# Current ENERGY STAR Certified Homes Policy Record

## ENERGY STAR Certified Homes Policy Record

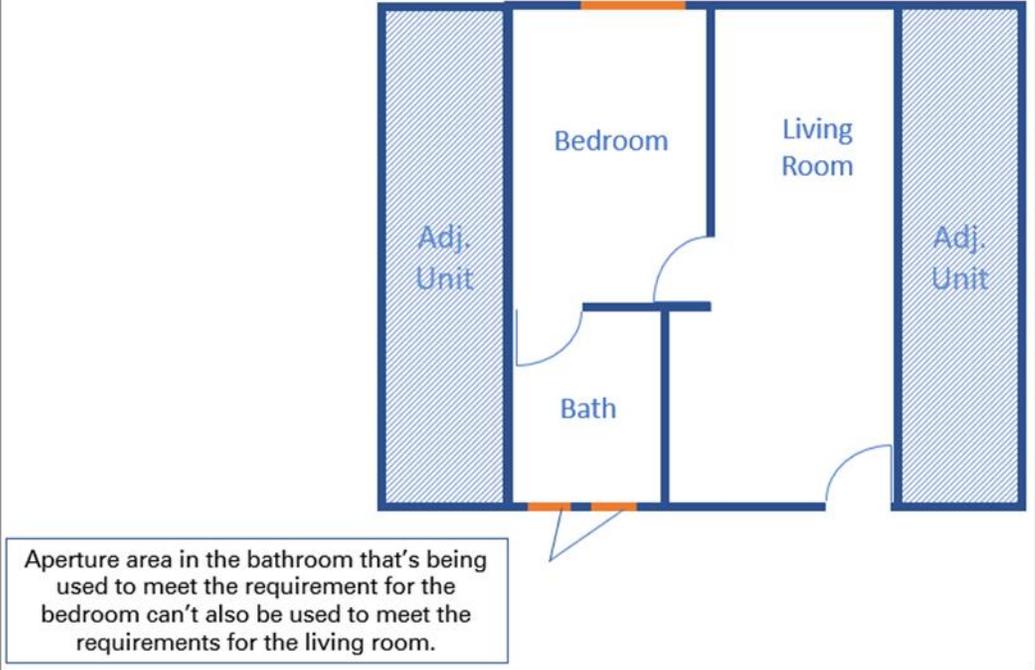
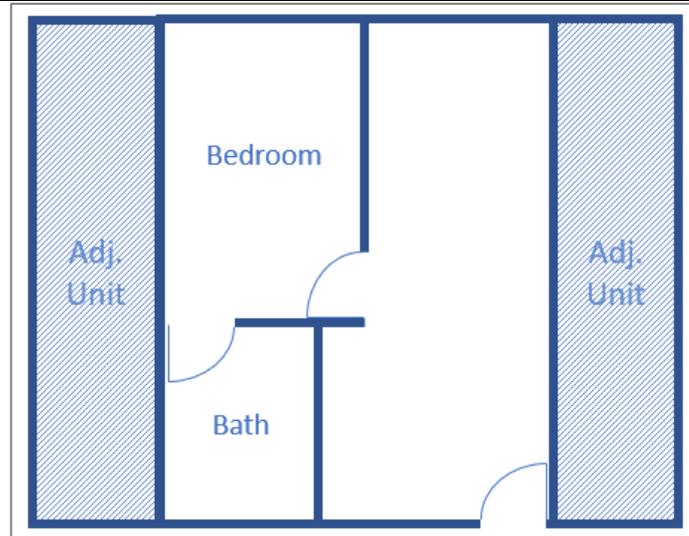
If apertures must be on walls that directly bound the primary living area, then there is no way to meet this Item unless the design incorporates wing walls, which stakeholders have indicated are not common practice.

Allowing apertures to be located on walls outside the primary living area would ease compliance while not necessarily compromising the original intent of the requirement, to promote effective natural ventilation.

**Exhibit 2**

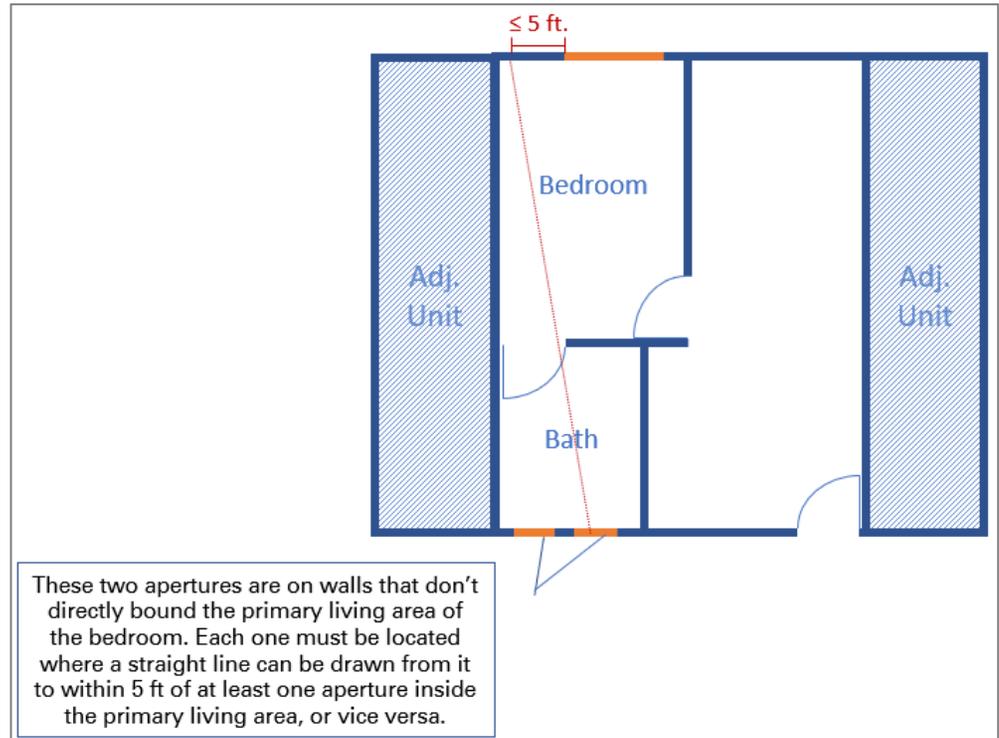
“effectively aligned” if a straight line can be drawn from one aperture to within 5 ft. of the other aperture. See Exhibit 2.

**Exhibit 3**

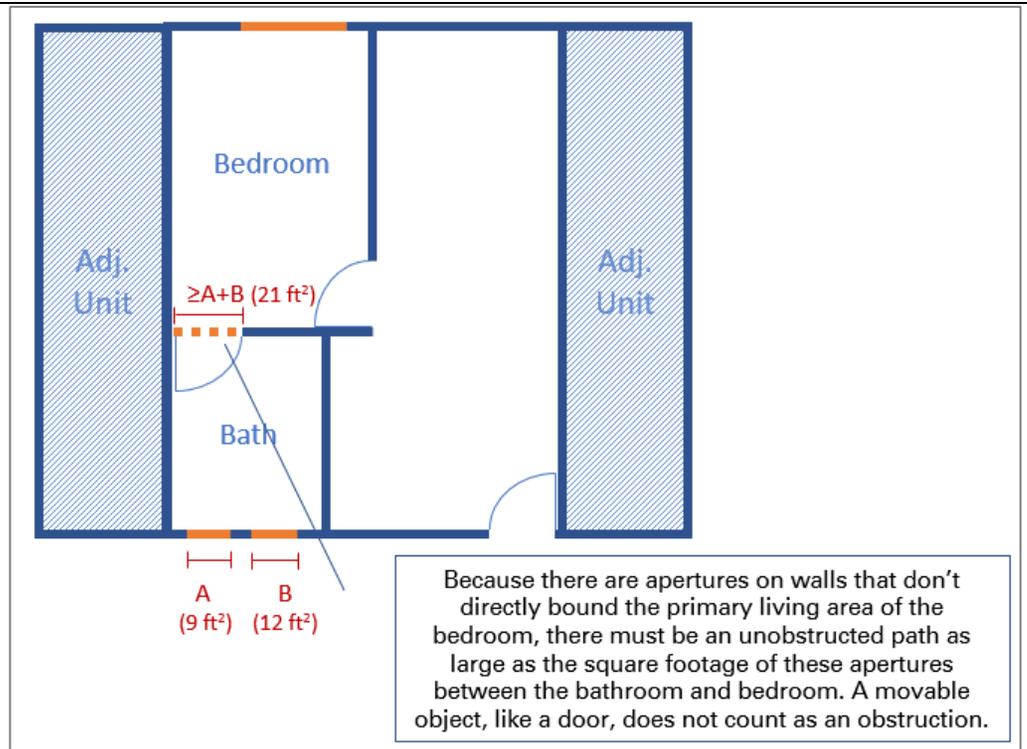
Finally, if the apertures are on walls that don't directly bound the primary living area, then an unobstructed path will be required between the primary living area and those apertures that is at least as large as the square footage of those apertures. See Exhibit 3.

While implied, if the apertures are outside the primary living area, then only the floor area of the primary living area needs to be included when calculating the required operable aperture area; the floor area of adjacent spaces do not need to be included.
